## **Service Bulletins**

**Rolls-Royce Silver Cloud II**  
**Rolls-Royce Silver Cloud III**  
**Bentley S2**  
**Bentley S3**  
**Phantom V**

SERVICE INFORMATION FOR THE ROLLS-ROYCE SILVER CLOUD III  
AND BENTLEY S. 3.

Fig. 1. Three types of camshaft fitted to V8 engines.

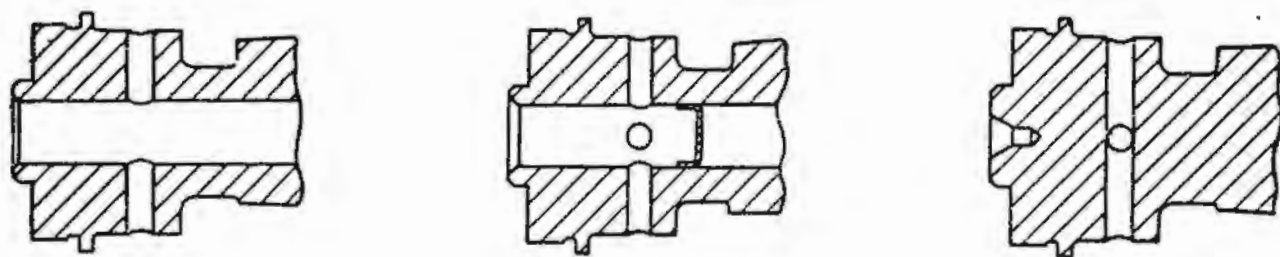
Three different methods of feeding oil to the camshaft bearings are employed on early production V 8 engines; these differences involve slight modifications to the camshaft and crankcase. The three stages of camshaft design are shown in Figure 1.

Fig.1 Shortened brake linings

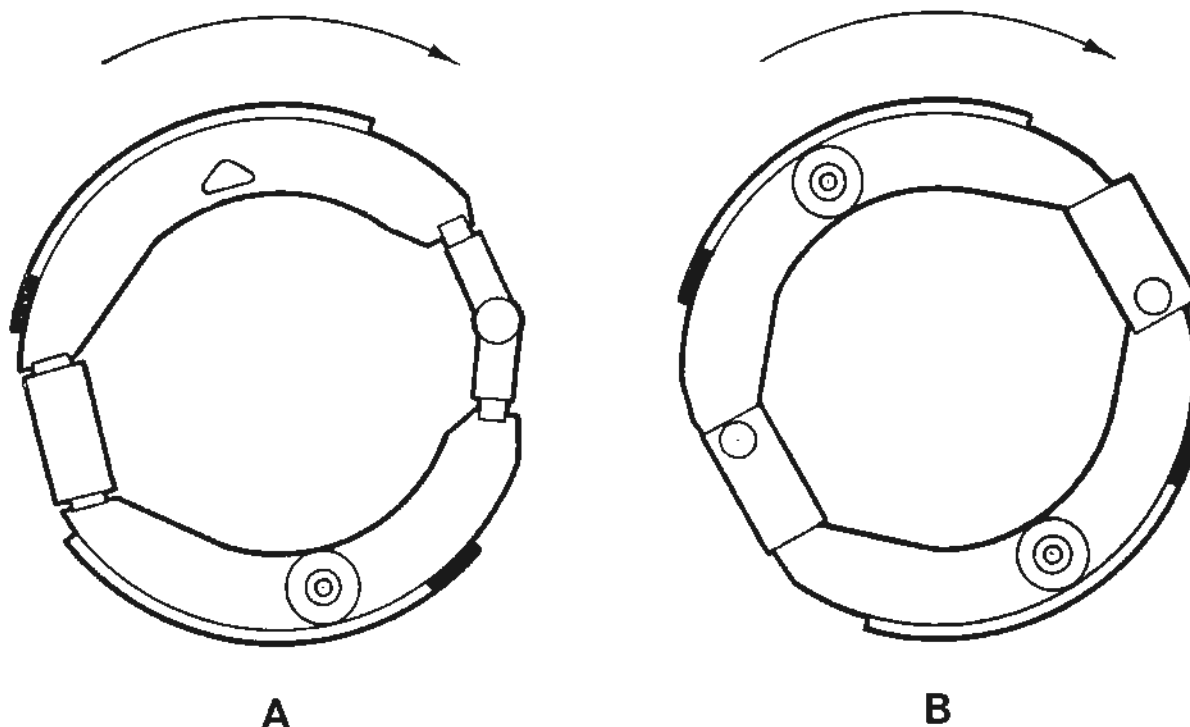
This Service Bulletin is issued to advise Retailers and Service Personnel that since supplies of linings UG.2071 and UG.1523 have now run out, all brake linings and brake shoe/lining assemblies supplied in the future by the Spares Central Stores will be of the shortened type. The part numbers of the various assemblies are listed in Spares Information Sheet 3.G.4.

Identify the shortened end of the lining. This can be done by comparing the angular distance between the pairs of rivet holes. The end of the lining which has the two adjacent pairs of rivet holes closest together is the shortened end. Place the lining on the brake shoe in the correct position. As described earlier, the linings have been shortened at the leading edge, this being seen more clearly in Figure 1. The shaded parts of the lining denoting the portions which have been cut off.

Fig.1 Diagram showing the stove pipe intake fitted forward of the oil breather outlet. 'A' shows the stove pipe nipping the swaged end of the new inlet pipe.

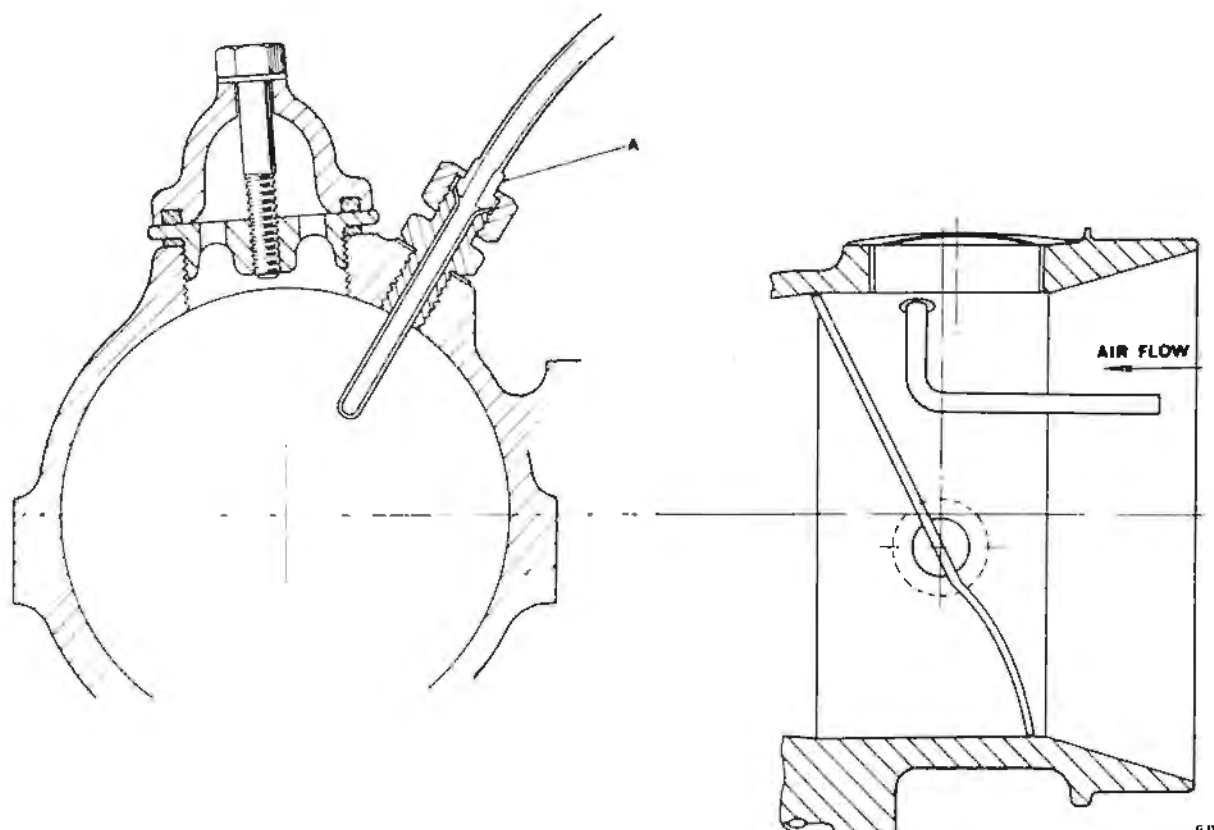
having a curved inlet pipe which faces directly into the incoming air stream, carrying the inlet forward of the breather outlet. This is shown in Figure 1.

Fig.1 Modified radiator shutter assembly

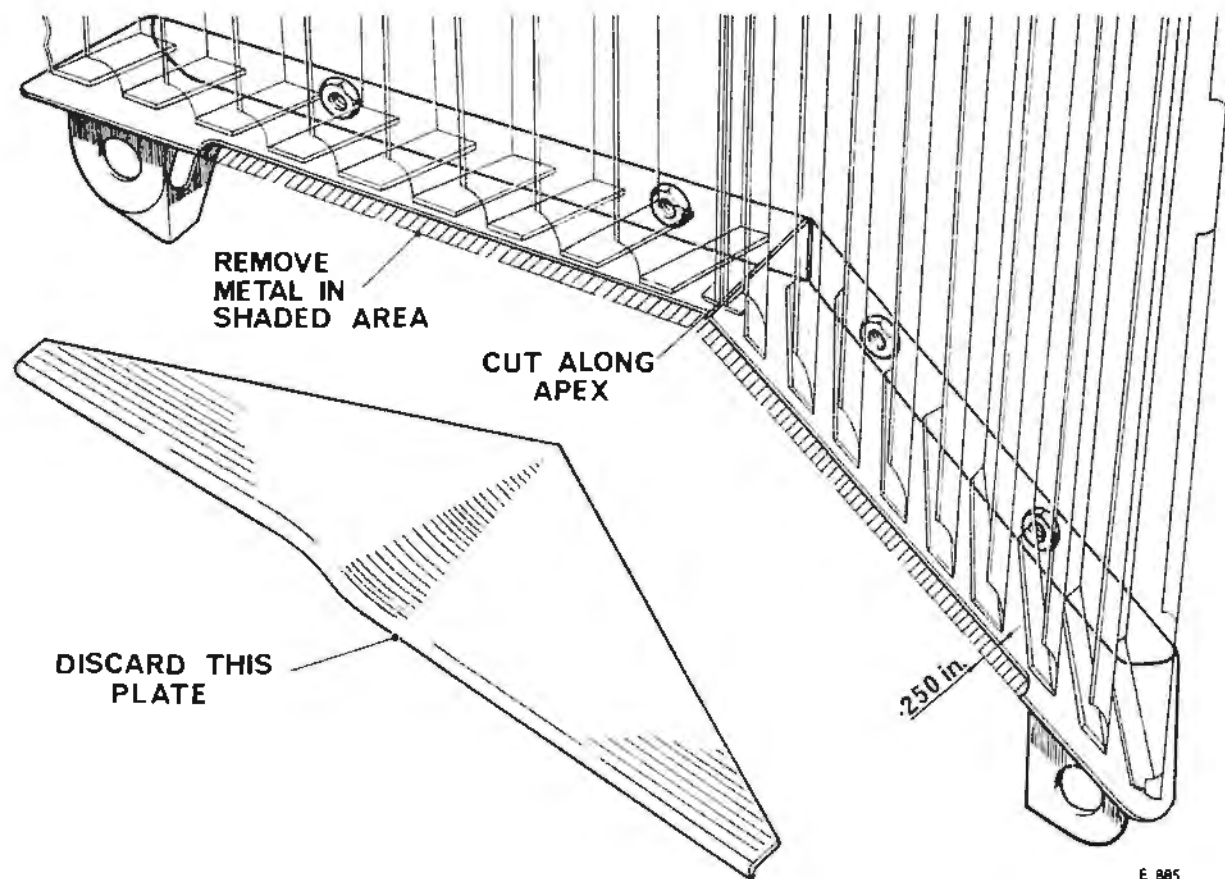
To eliminate the 'moan', the stiffness of the whole vane assembly was reduced so that its natural frequency of vibration was lowered sufficiently to take it outside the audible range. This was achieved by discarding the triangular shaped blanking plate which is spot welded onto the horizontal flange of the vee shaped lower bearing strip and by removing 0.250 in. from the rear side (i.e. spot welded area) of the lower bearing strip. The strip was then cut into two equal lengths by cutting along the apex of its vee form. For details of the modification see Figure 1.

- (1) Try to substantiate the customer's complaint if the prevailing weather conditions are as stated.
- (2) Remove the radiator shell.
- (3) Remove the vane assembly complete.
- (4) Carefully remove and discard the triangular shaped blanking plate from the vee shaped lower bearing strip onto which it is attached by means of spot welds.
- (5) Reduce the width of the horizontal flange of the lower bearing strip by removing metal from the area shown shaded (see Fig.1).
- (6) Cut the lower bearing strip along the apex of its vee form, thus producing two separate strips (see Fig.1).
- (7) Treat the exposed metal surfaces resulting from operations (5) and (6) with a suitable paint.
- (8) Refit the vane assembly.
- (9) Refit the radiator shell.

Fig.1 Method of fitting styling strips  
to front doors and wings

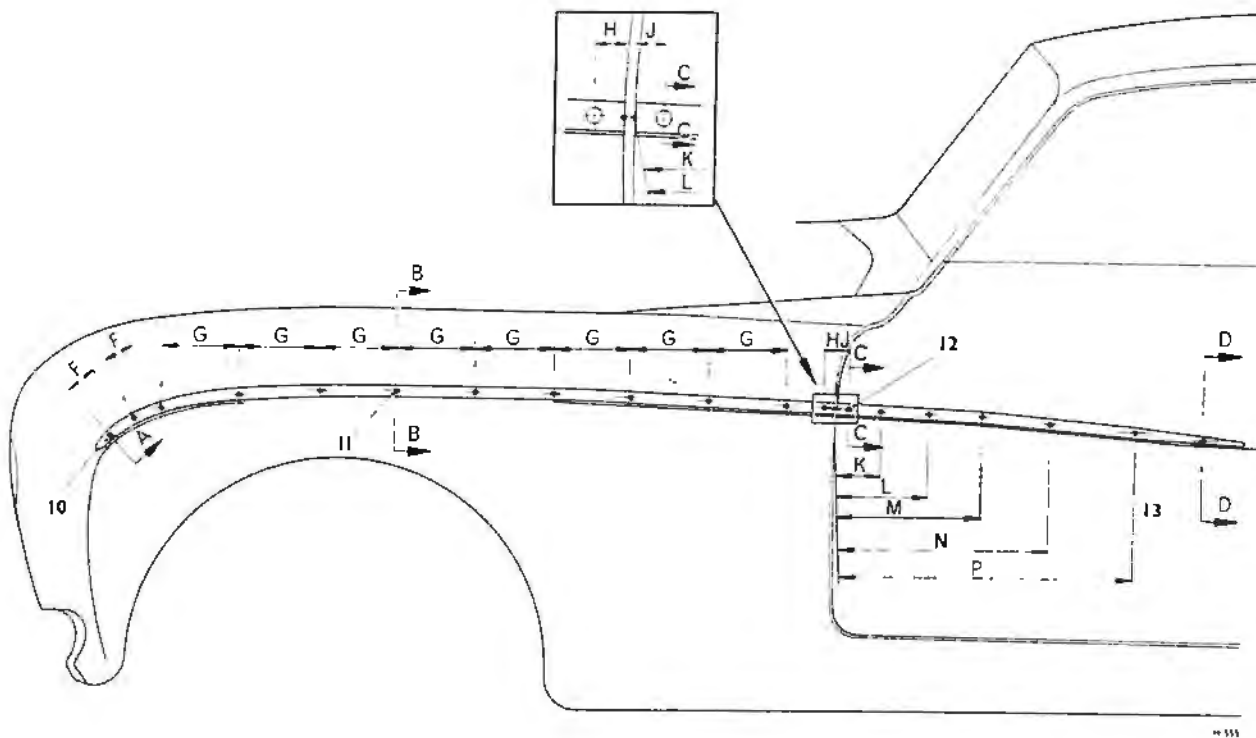
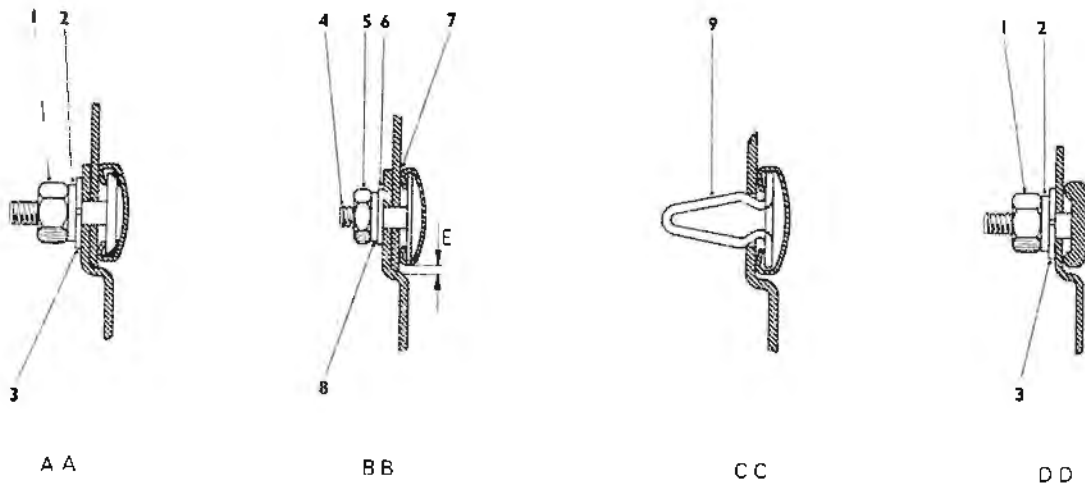
1. Apply a length of masking tape along each front wing and door to cover the areas which are to be drilled as shown in Figure 1.
2. Mark onto the masking tape, the correct position of each hole to be drilled. The hole centres should be marked so that when the styling strips are fitted, their lower edges are approximately 0.062 in. (1.59 mm.) above the existing styling lines.
